Application No.: PL2022230

RE: **Response to plan review report dated June 24, 2022**
Arcade Alley Outdoor Space –Commercial Preliminary Development Plan

2. C103 Utility Plan:

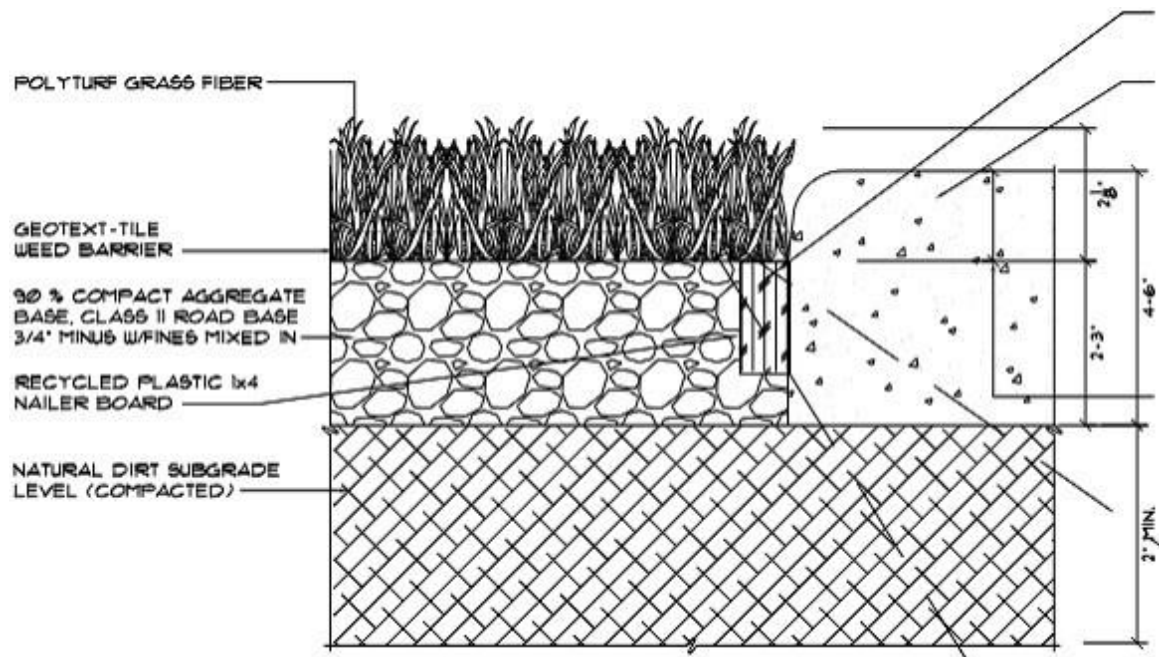
a) Floor drains cannot be connected to the storm drain.

The floor drain shown in the outdoor bar area will connect to the existing sanitary sewer line.
